# Monte Scientia Project

## Heritage Response to Submissions – SSD10393

This report has been prepared to address heritage related concerns raised by the Department of Planning, Industry and Environment (DPIE) and North Sydney Council in response to a State Significant Development application for the Monte Scientia Project, at Monte Sant Angelo Mercy College, North Sydney.

Figure 1 - Diagrams showing the reduced portion of fence to be removed. (Source: Haybal)

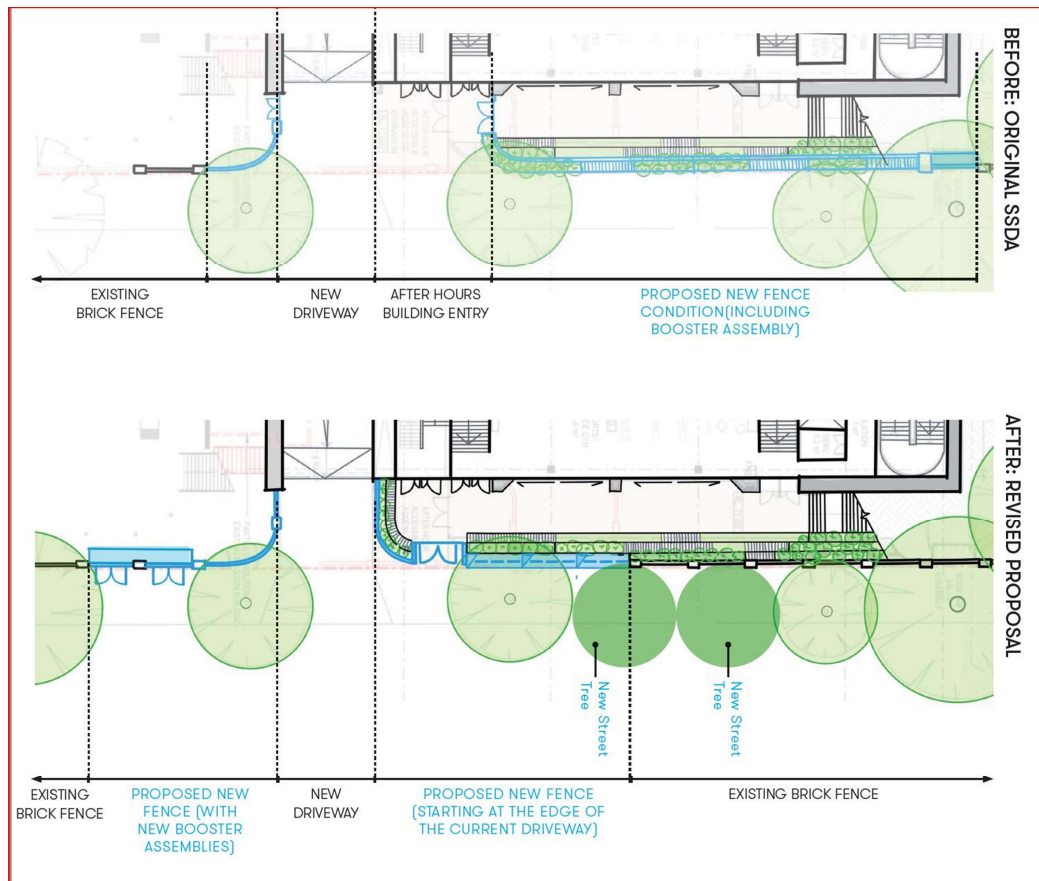
- *Demolition of Existing Miller Street Historic Wall – The existing wall contributes to the Catholic cultural history of the enclosed school site and also contributes to the Miller streetscape. It is noted on the site's Statement of Significance as being an item of heritage significance. Demolition of the wall is therefore not supported.*

*It is recommended that the proposal be redesigned to retain the existing wall.*

As recommended, the design of the proposed changes to the Miller Street wall has been revisited, resulting in the retention of a greater extent of existing wall fabric along with the refinement of the detailed design to those portions of the wall to be altered. The alterations to the wall are in response to the existing driveway entry being relocated further to the south; the resulting wall design is proposed to infill the current entry opening.

The new wall has been designed to provide the existing visual definition of the site, required light to the setback behind the wall as well supporting the opportunity for integrated interpretation. The contemporary design also meet the criteria for distinguishing new from old fabric in reconstruction works.

Figure 5 - Diagram identifying the primary alignment lines between the heritage buildings and the proposed building. This diagram also clearly identifies the relationship between the existing Holy Grass and the new landscaped courtyard. (Source: Hayball)

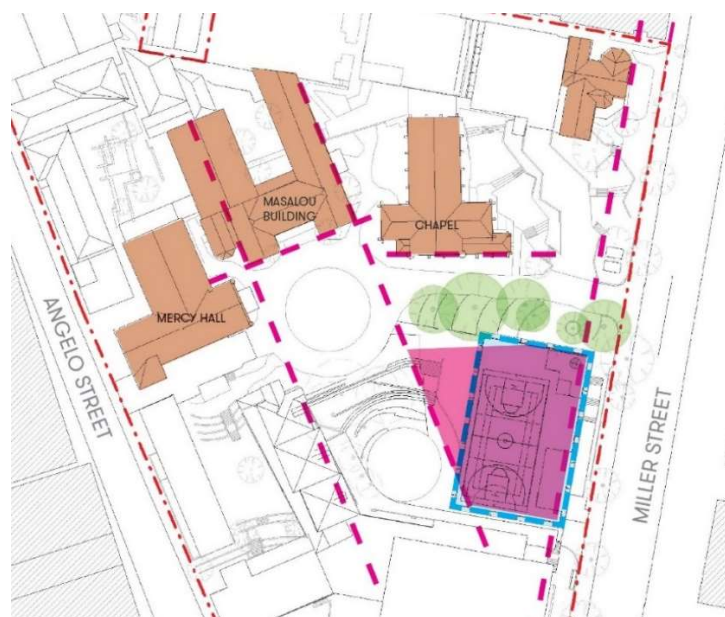
- *Curtilage and Setting – The visual curtilage and setting of the heritage significant buildings should be retained. The facades of Mercy hall, the Library, Masalou and Treanor are all aligned either perpendicular or parallel to each other and assist in creating a spatial relationship with each other in a square formation as well as creating a sense of enclosure to the Holy Grass. The chapel ... has a traditional east/west alignment, opening up to the driveway and gate. The McQuoin Centre on the corner of Berry/Miller Streets is set far enough downslope and away from the Holy Grass and the significant buildings that it reads as a separate built element on the site and has little relationship with them.*

*The proposed development, however, relates to none of the historic existing alignments and established curtilage but instead relates to the alignment of the McQuoin Centre and the Miller Street frontage. The new development should acknowledge the alignment of the heritage buildings as it will be seen in the context of the historic buildings due to its proximity.*

The siting of the proposed building intentionally addresses Miller Street, creating the opportunity to extend the existing open area around the Holy Grass into the heart of the lower campus as shown below in Figure 4.

It is appropriate in heritage terms to maintain the alignment with the McQuoin building as it continues the existing pattern of development on the site and it materially improves views of the heritage precinct from within the school campus.

*Figure 6 - Excerpt from the Architecture response to Submissions identifying the key building amendments. Further elaboration on these elements is included in the design report. (Source: Hayball)*

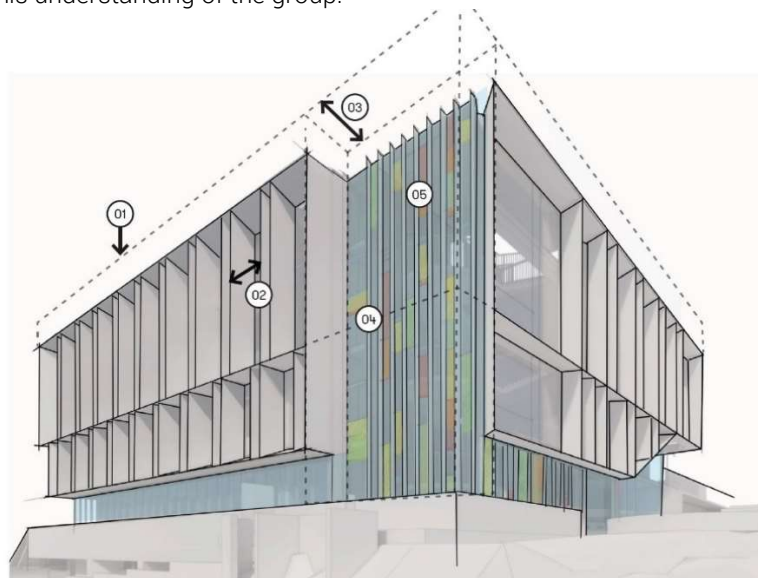
*Because of the proposal's bold design and monolithic massing, it is likely that it will visually overwhelm the traditional setting of the group of heritage significant buildings and their visual curtilage over the Holy Grass. Although the northwest corner has been 'eroded' at ground level on the northern elevation of the design, the curved frame on the northern elevation takes the eye to the right angled corner of the building on the upper levels giving it visual dominance. The new development will therefore confuse the setting of the heritage items by its corner conflicting with the established building alignments.*

*It is therefore recommended that to comply with part B Section 13.4 Objective 01, Provisions P1 and P3 that the façade on the north elevation be parallel to the Chapel or that it run approximately half way along its North Elevation to be parallel with the Church. This will acknowledge the alignment of the Chapel and the established building alignments at the cultural core of the site rather than creating an incursion. It will also allow the formality of the driveway to the highly significant Holy Grass to be retained and potentially enhanced.*

The amendments to the design identified in response to the received submissions have resulted in a reduced height with a more refined façade, particularly through the setting back of the north western corner which softens the visual impact of the building in views of the Chapel. The setting down of the building into the site, the muted and natural colour palette, alongside the understanding of the building as a backdrop to the new landscaped courtyard minimises the likelihood of the new building visually overwhelming the heritage precinct. The current setting for the Chapel includes significant established landscaping which will be retained and enhanced by the proposed landscaping extending to the southern side of the driveway.

The proposal is to replace the existing structures with a new building in the vicinity of the heritage precinct; this has been the pattern of development on the site since the school's occupation. The key amendments to the proposal described in the Architectural Response to Submissions that specifically improve the visual and physical relationship with the heritage precinct include a reduction in height, increased corner setbacks, refinement of the façade articulation and materiality and the inclusion of the corner 'lantern detail.'

The revised proposal has reduced and refined the south western corner detail of the building to incorporate a 'lantern element' that addresses the school entry and the Chapel. This approach provides a more appropriate acknowledgment of the religious underpinning of the school community and does not undermine the subtle significance of the east-west orientation of the Chapel. For this reason, it would be inappropriate to consciously turn a portion of the new building to arbitrarily read as parallel to the Chapel.
